Chiltern Railways (Bicester to Oxford improvements) Order 2012 and Deemed Planning Permission

Report by Brian Hemsworth (Independent Noise Assessor) on

Noise Scheme of Assessment for Route Section H

Report Reference 0221083/11/H05 dated 11th February 2015 prepared by ERM

Figure 1.3 Cross Section at PI 17, 396 Woodstock Road

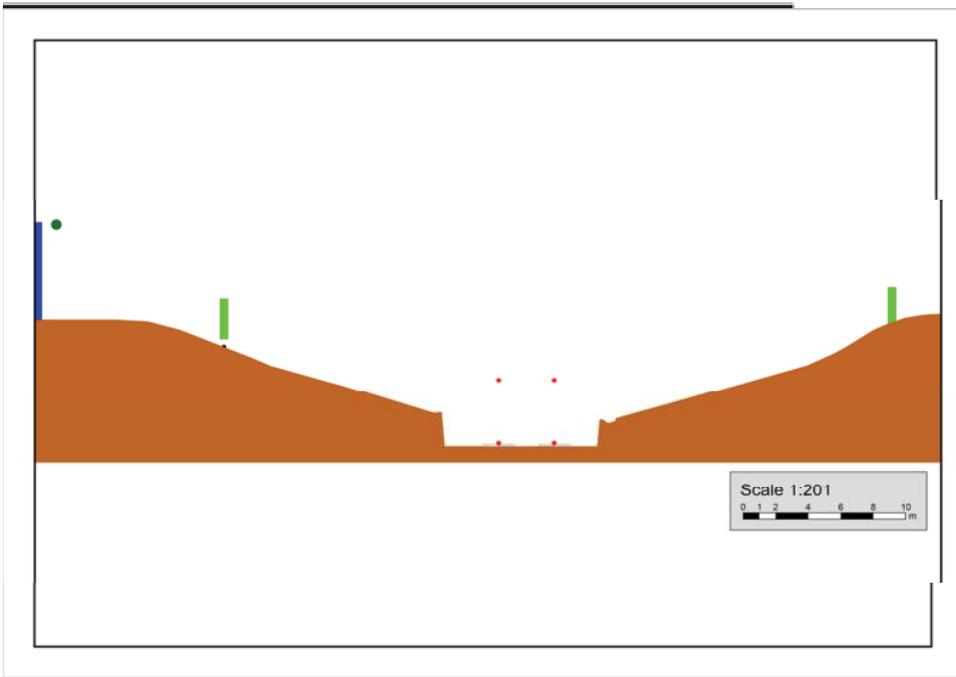
5. Receptor PI17 – see Question 4.
6. Receptor SOA 8 - Higher Day and night levels are predicted (+8-9 dBA). Are there other propagation factors to include?

5. The cutting is predicted to provide screening from train noise at NSR PI 17, particularly from trains using the Down line. This can be seen in the cross section provided in *Figure 1.3* of the previous additional information document ⁽¹⁾.

Figure 1.5 Cross Section at SoA 10, 15 Sheriffs Drive

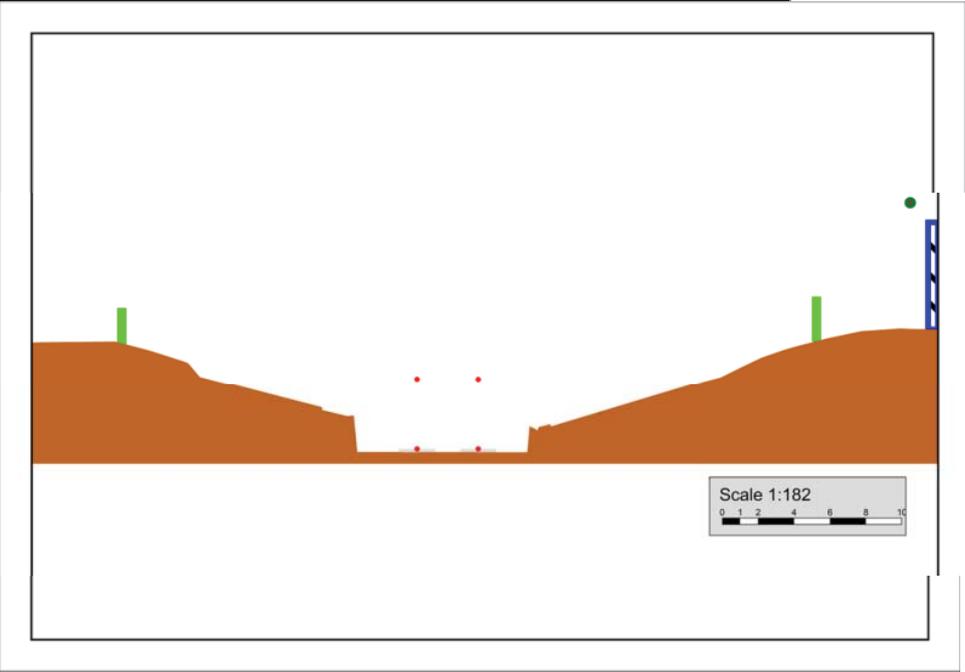
7. Receptor SOA9 - Higher Day and night levels are predicted (4 - 5 dBA). Does the top of the retained cutting wall act as a barrier?
8. Receptor SOA10 - Higher Day and night levels are predicted (2 -3 dBA). Does the top of the retained cutting side act as a barrier?

8. The cutting is predicted to provide screening from train noise at NSR SoA 10. This has been tested by replacing the cutting topography with flat ground. Using flat ground gives predicted noise levels, LAeq of 61 dB during the day and 60 dB at night, which can be more readily compared with your predictions.
9. The cutting is predicted to provide screening from train noise at NSRs SoA 13 and SoA 14. This can be seen in the cross section for NSR SoA 13 provided in *Figure 1.9* of the previous additional information document (1).
10. NSRs SoA 15 and SoA 17 are screened from all or part of the railway by intervening properties, as shown in *Figure 5.1c* of the SoA. The situation is similar at NSR SoA 16.

Figure 2.1 *Cross Section at PI 16, 398 Woodstock Road*

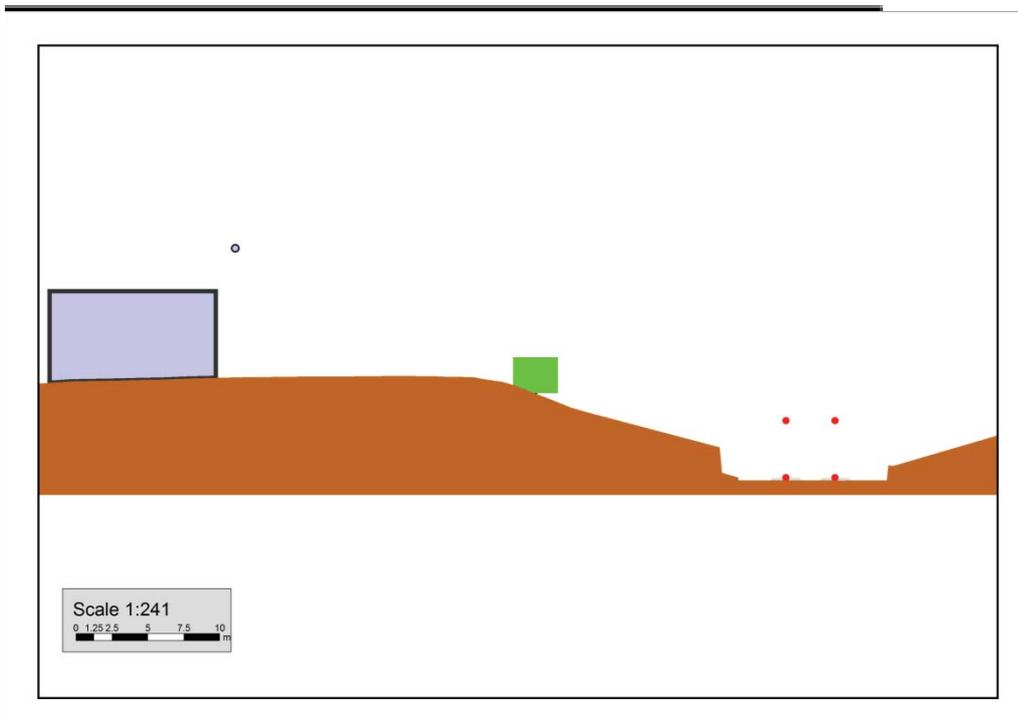
3. Receptors SOA5 & SOA6 - See Question 2.
4. Receptor PI16 – Higher Day and night levels are predicted (+5 dBA). Does the top of the retained cutting side act as a barrier?

4. The cutting is predicted to provide screening from train noise at NSR PI 16, particularly from trains using the Down line. This can be seen in the cross section provided in *Figure 2.1* below.

Figure 1.1 Plan View of Receptors

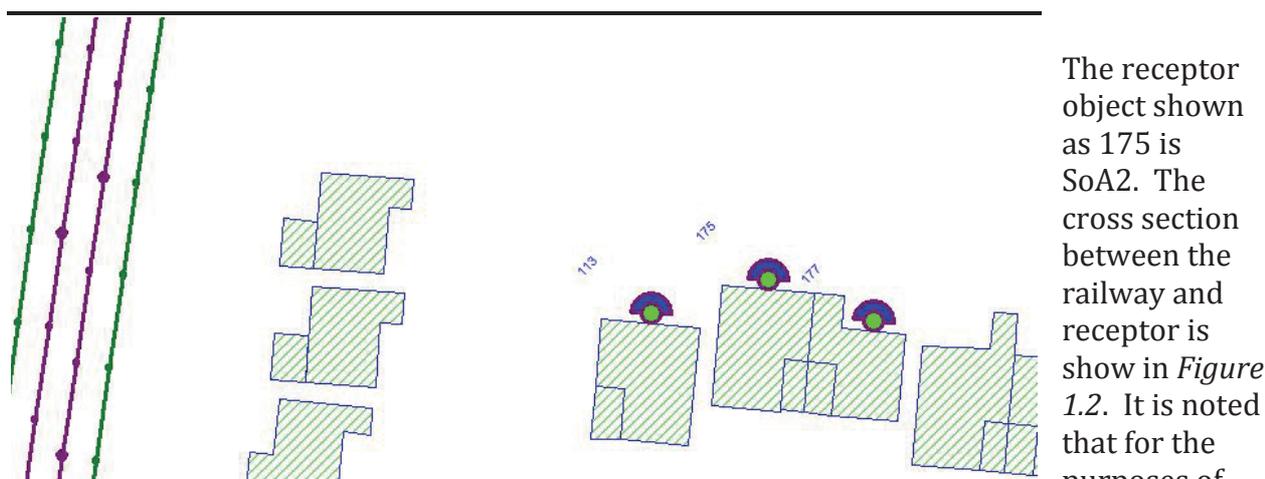
Following the responses I have received with respect to earlier questions, I am happy that the levels presented in Table D4.1 can be used to compare the noise levels against the Noise and Vibration Mitigation Policy and the requirements of the Planning Conditions. The same applies to the mitigated levels in Table D4.2 with the exception of receptors PI14, SoA3 and SoA4 where although the receptors are in the shadow zone of the barrier the predicted noise reductions are similar to those I would expect for a receptor in the illuminated zone, Could you please confirm the levels in Table D4.2 for these receptors.

To assist in the noise modelling checks we have extracted cross sectional views from the railway to the group of receptors where the IE has requested confirmation about screening effects at PI14, SoA2 and SoA3. SoA 4 was also question, but the cross section shows the source heights relative to the barriers which we believe explains the relatively small screening values that might be expected in for this section of track which also affects SoA4.

The plan view is shown in *Figure 1.1*.

Figure 1.2 Cross Section to SoA2

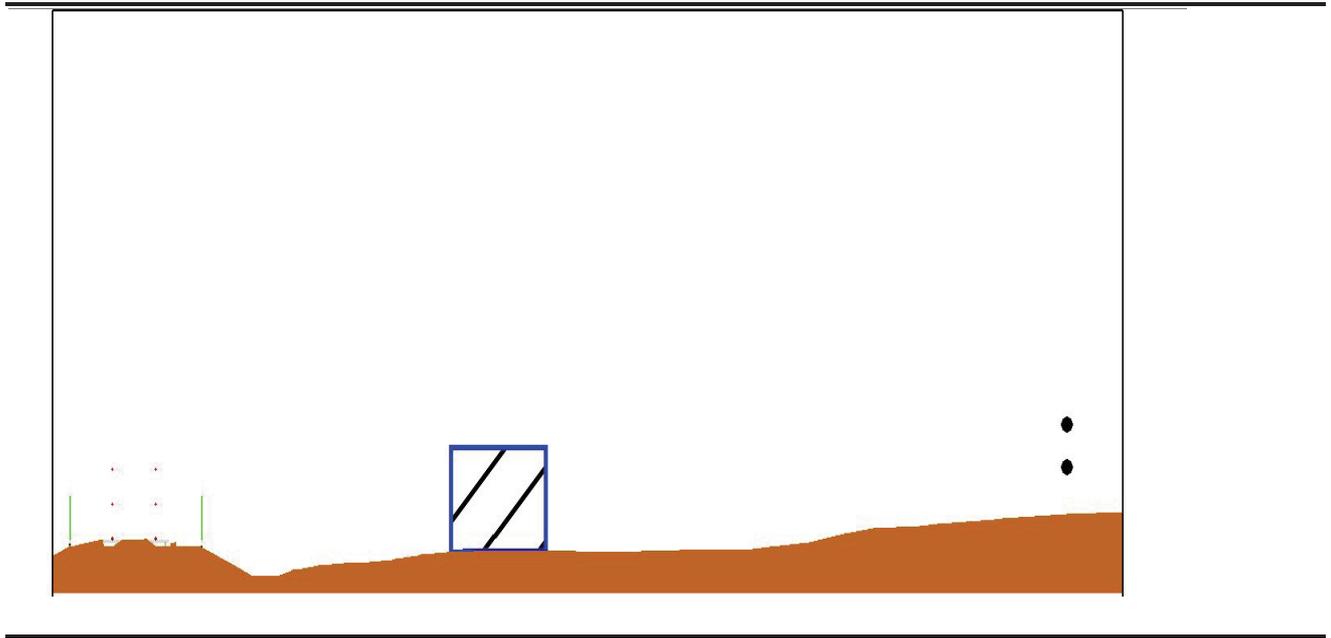
I am happy that, in general, the source of "on – power" noise will be above the line of sight from receiver through the top of barrier and there will be little or no screening of this noise source. If "on – power" noise is the major source of noise from the railway I would accept that there could be little or no reduction in the day or night L_{Aeq} .

My modelling, however, indicates that that, at most receptors, rolling noise L_{Aeq} exceeds "on power" L_{Aeq} by levels in the region of 15 dBA. The planned barriers will be effective in reducing rolling noise and with this differential there should also be a reduction in total L_{Aeq} , as my model indicates.

The attenuation of rolling noise by the barrier exceeds the natural screening by significant amounts, except for receptor SoA8, and will therefore be effective in reducing rolling noise. In general, I therefore predict lower L_{Aeq} noise levels in the presence of barriers than are contained in Table D4.2. Whilst this difference is in the right direction with regards to the assessment I would appreciate any comments you have by way of explanation of the difference in the modelling results.

The receptor object shown as 175 is SoA2. The cross section between the railway and receptor is show in *Figure 1.2*. It is noted that for the purposes of

the screening calculation we are only interested in the section of the railway which is screened only by the barrier. A perpendicular cross section has been shown consistent with CRN.

The cross section produced by the model shows the source heights assumed for the closest (up) line and the furthest (down) line. During the night (the most critical period) there are locomotives that are on-power on the down line which are travelling up hill. The source height of these will be 4 m above the rail, which is equivalent to the highest of the three dots that are shown. Since the barrier height is only 2.5 m above the rails this is not screened. The other trains are in the acoustic shadow zone and will benefit from screening with the source being the lowest of the three source dots at the railhead.

Further inspection of the location of the receptors in question in relation to the railway shows that whilst the barrier does provide screening to some of the railway, it is the unscreened part of the railway which limits the apparent screening effects that you have calculated. In the SoA we have used P114 and SoA3 to determine the barrier length to avoid noise levels over the night-time noise threshold of 45 dB LAeq, 8 hr, and have not extended the barrier further than is necessary for the requirements of the Noise and Vibration Mitigation Policy to be met.

The reductions required to meet the standards in the Policy for this are only relatively small at SoA3 (3 dB) and hence it may appear that a high level of screening is not being achieved and that illuminated zone screening is being applied, whereas this 3 dB reduction is simply all that is required. It is noted that at P114 a higher reduction of 6 dB is shown in the SoA and at SoA 4 a reduction of 7 dB is shown which are both in excess of what would be expected in the illuminated zone (i.e. < 5 dB).

Extending the barrier further to screen the track to the north and south of the proposed barriers would result in higher overall noise level reductions. We have tested this in the model and found noise reductions compared to the unmitigated case of 11 dB at P114, 7 dB at SoA3 and 9 dB at SoA 4.

It is consistent that reductions are no higher than 11 dB overall due to the relative difference between the on and off-power noise contributions that have been highlighted in the above comments and the fact that the screening is only effective at screening the off-power trains. We are therefore confident that the more comprehensive approach that we are implementing in our model is responsible for the differences that you have highlighted.
